APPLICATION

PERCOLATION TESTING

RE: Percolation Test Application
Maryland Department of Transportation
Project Number: HO 314-040-771
John W. Harris, Jr. Property
Item Number: 61101
Tax Map: 41 Parcel Number: - Not Identified

RE: Percolation Test Results Application
Number: A47997
Proposed Use: Recorded Lot
Property ID: Project # HO-314-040-771
Lot off Southside Guilford Road at
Freetown Road Intersection
Tax Map: 41 Plat Number: 52980

SCALE 1" = 50'
PLAT No. 52980

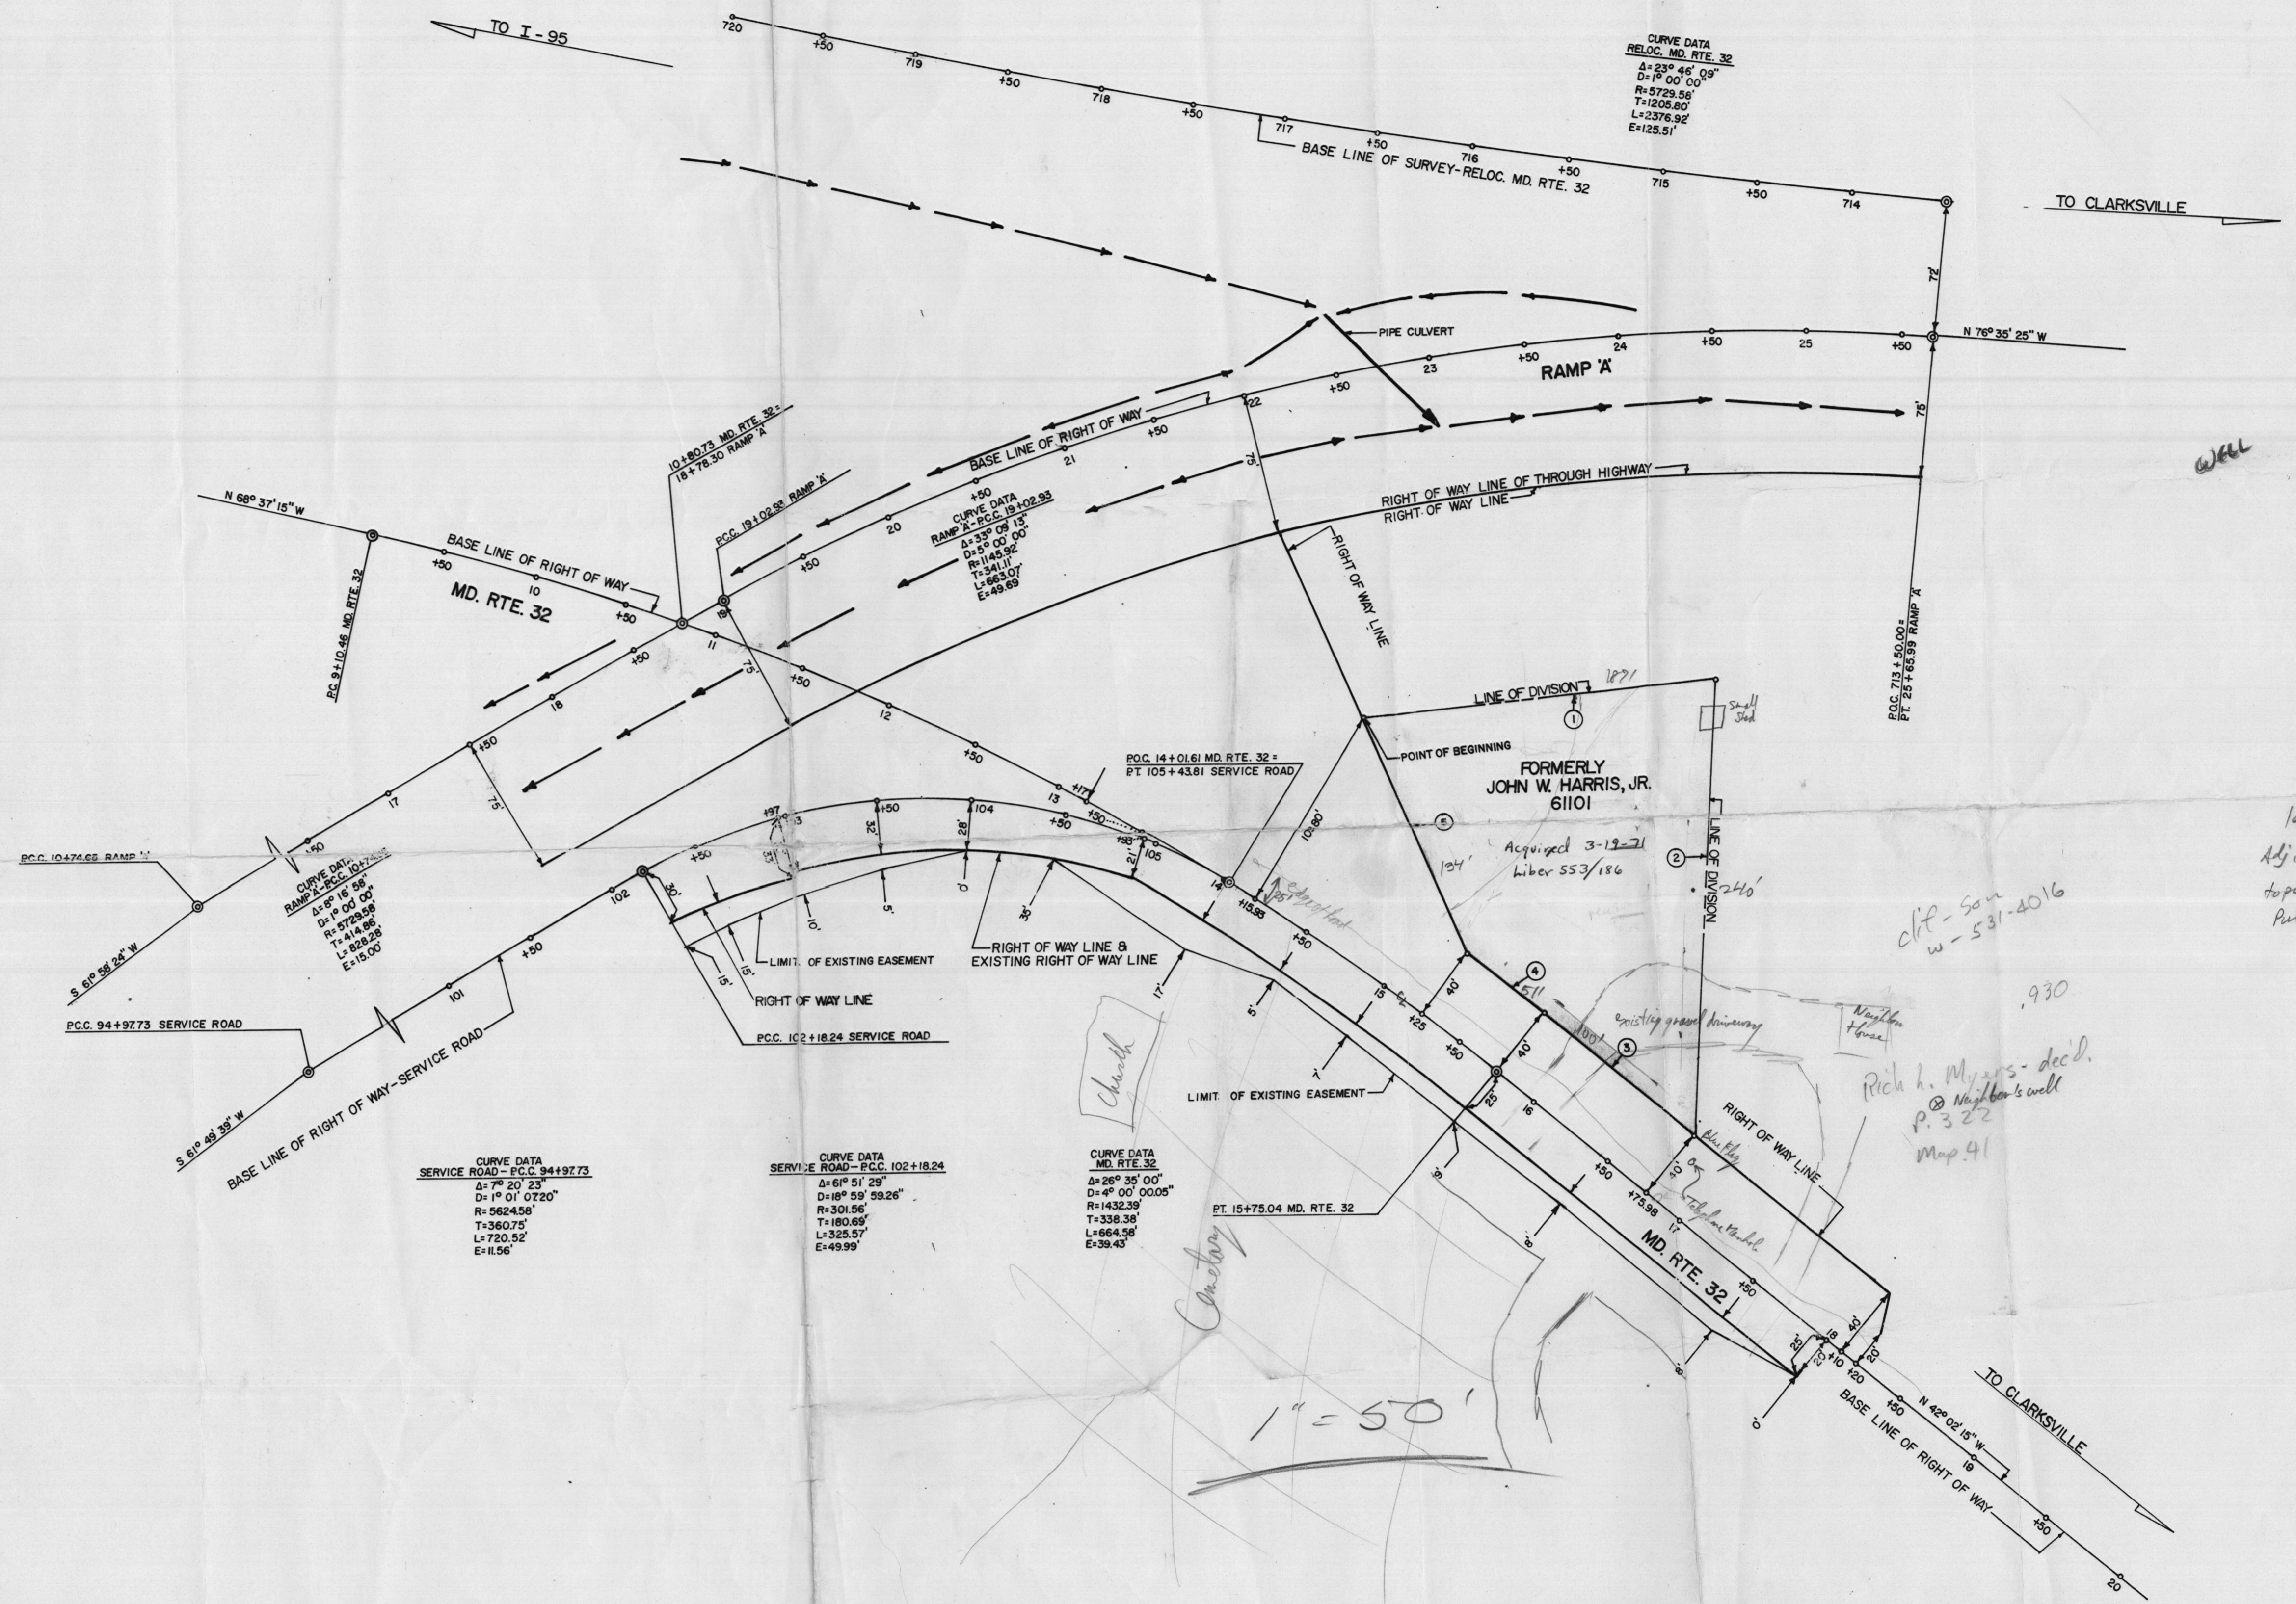
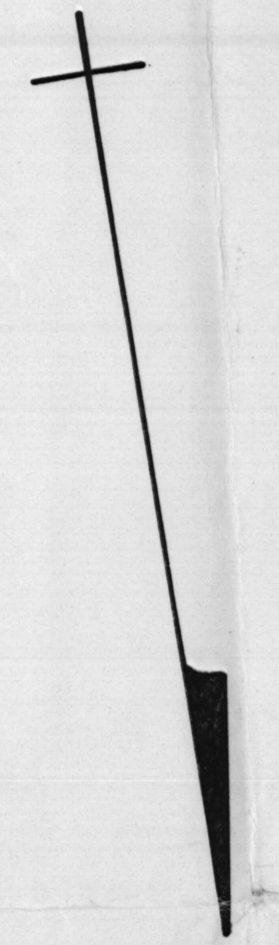
Repair
P# 31055
possibly adjacent house?

location?
Adj. Septic wells
topo.
Pub.?
